DEVIATION REQUEST AND DECISION FORM

The Hills at Lorson Ranch (CDR 20-007) Pedestrian Ramp Deviation

Deviation for Removing Pedestrian Ramps
 The Hills at Lorson Ranch

DATE: Nov 24, 2020	JOB NO: 100.061
SCALE: AS SHOWN n/a	FIGURE NO: 1

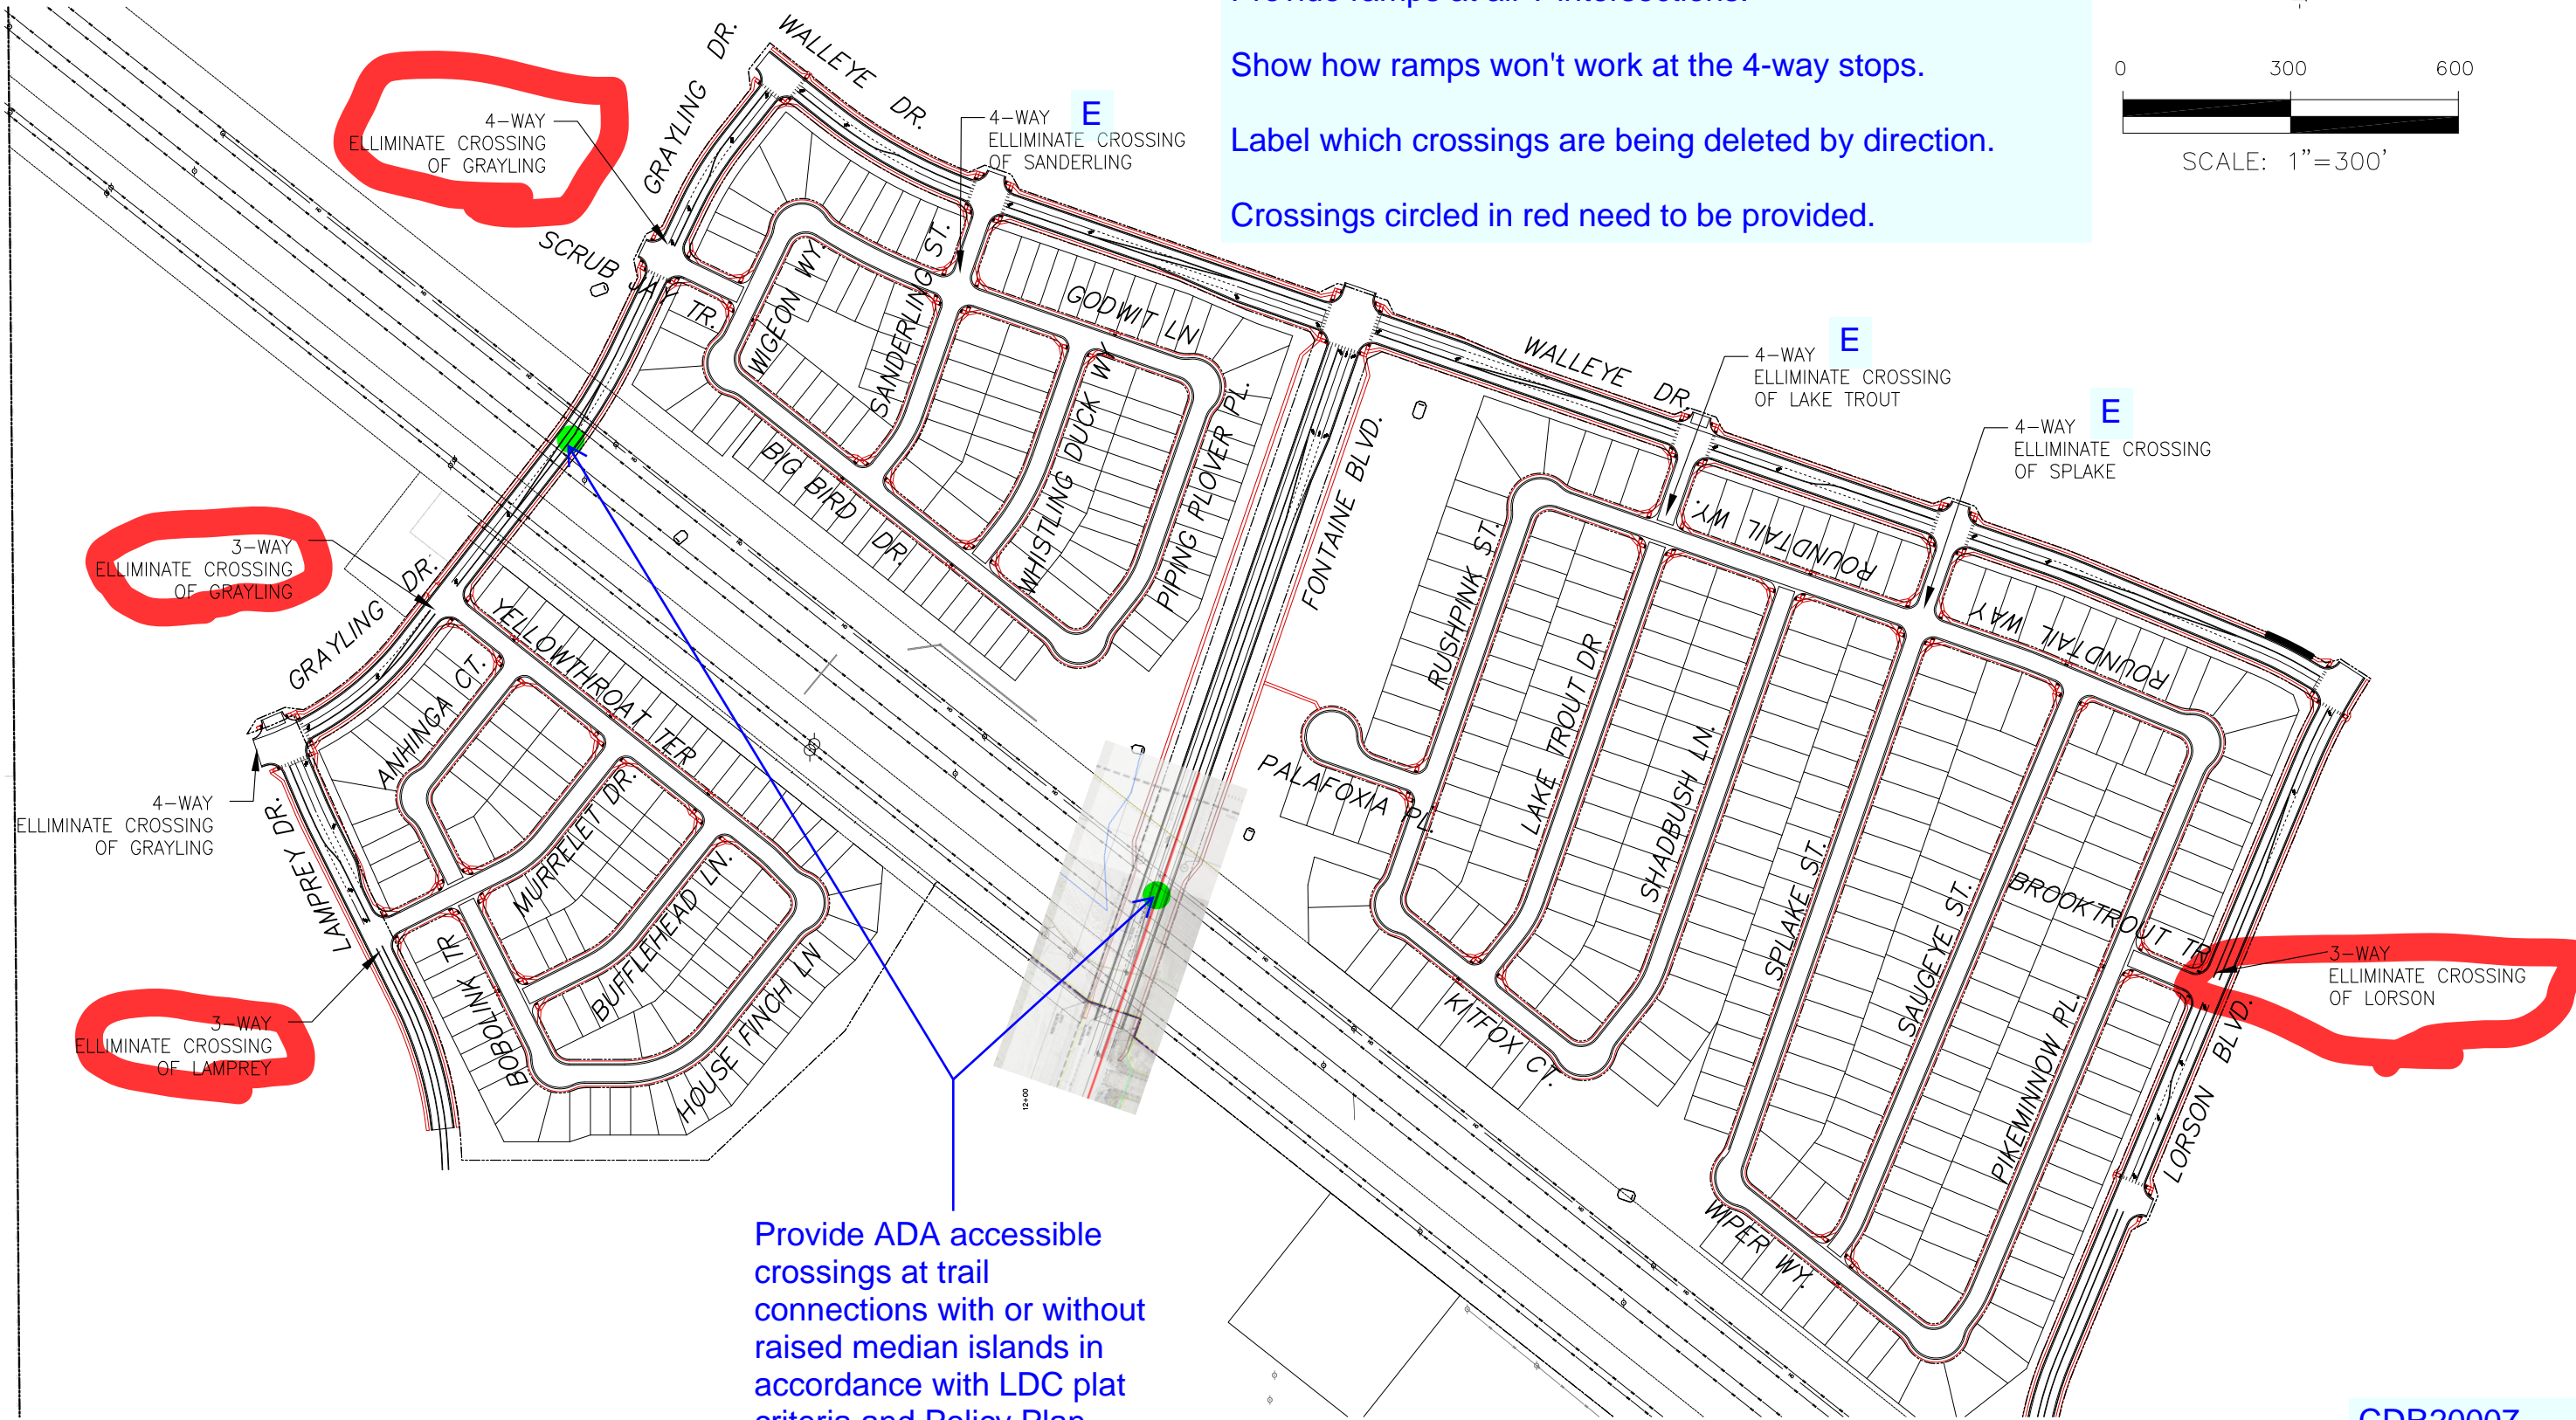
Provide ramps at all T intersections.

Show how ramps won't work at the 4-way stops.

Label which crossings are being deleted by direction.

Crossings circled in red need to be provided.
